Northern Corporation Ltd.- Sreepur

Northern Garments Limited

Tepirbari, Sreepur, Gazipur, Bangladesh
(24.240588, 90.417995)
5th January 2021 & 1st February 2021

Connecting Slab between Production building and Store building

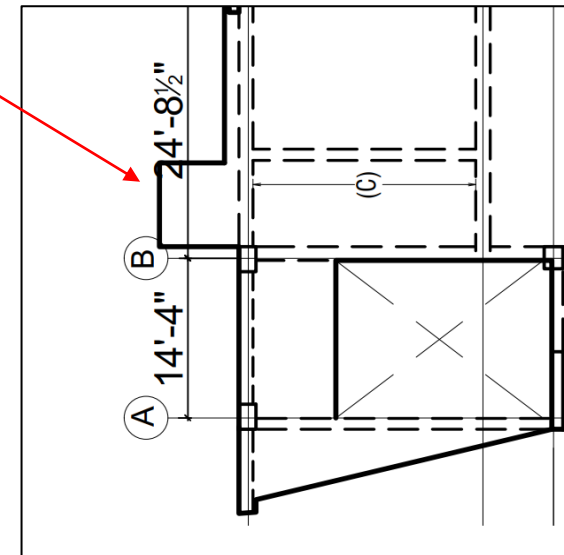
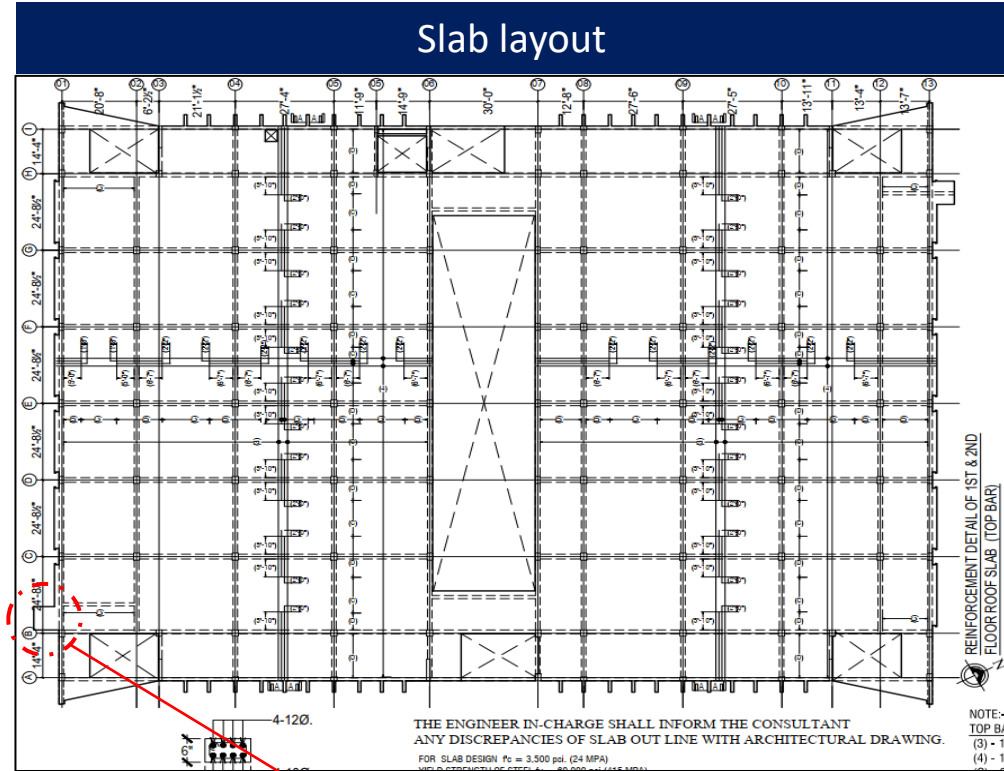
According to slab layout drawing of production building, the marked portion is a cantilever slab between production building and store building. But the slab was found structurally connected between both structures. This slab is susceptible to different movement from two different structures. The load transfer mechanism via this slab and capacity is required to be assessed.

Item No.	Observation	Recommended Action Plan	Recommended Timeline
01	Connecting Slab between Production building and Store building (Production Building)	Building Engineer to check the capacity of the slab of cantilever bridge and prepare an assessment report.	6-weeks
02	Connecting Slab between Production building and Store building (Production Building)	Produce & actively manage loading plan for this slab panel considering slab capacity.	6-weeks
03	Connecting Slab between Production building and Store building (Production Building)	Complete implementation of any remedial works deemed necessary by the assessment report.	6-months
04	Absence of design documents (Production Building)	Factory engineer is required to prepare the design documents including a design report, and a set of structural drawings in compliance with section 1.9.1.1 and section 1.9.1.2 as per BNBC part 6 and submit to RSC for review.	6-weeks

Slab layout of store building

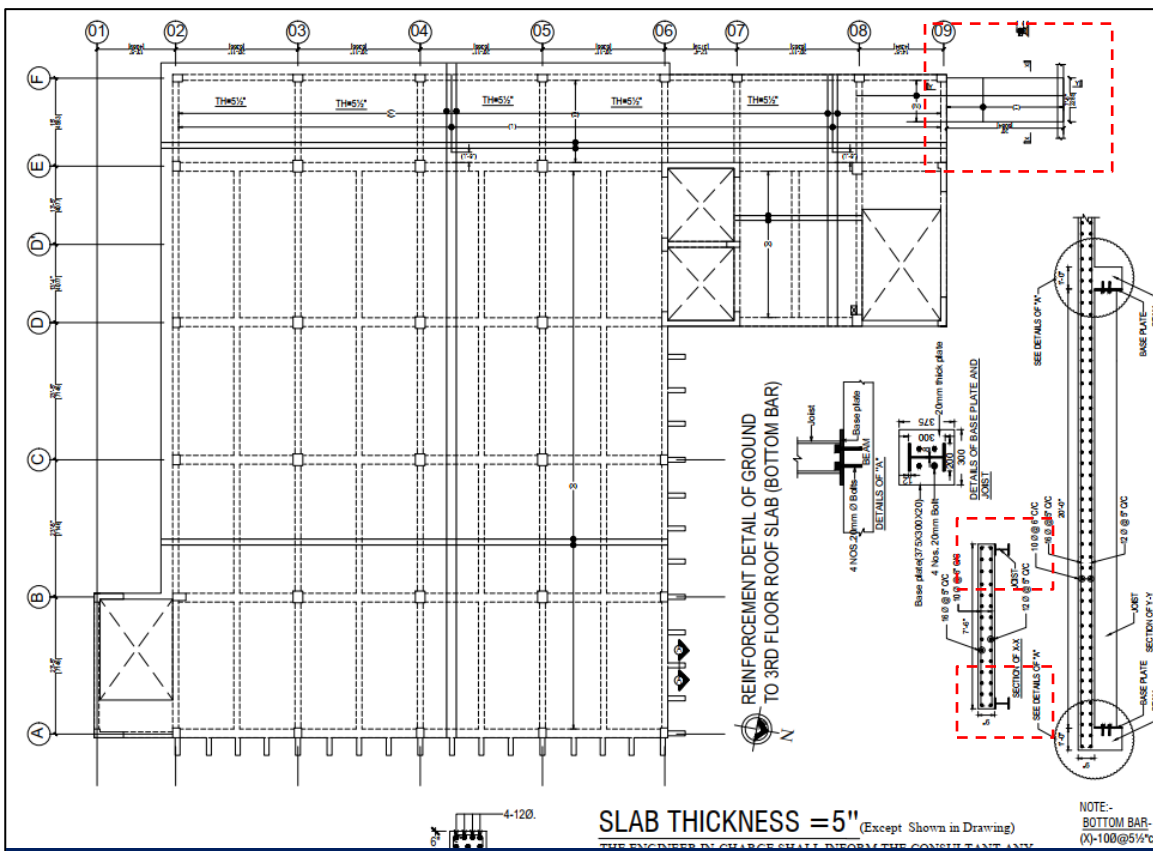
The slab of the connecting bridge connects the production building and store building. According to drawing, there should be two Steel I joist to support this slab. During inspection, this I joist was not found beneath of this slabs.
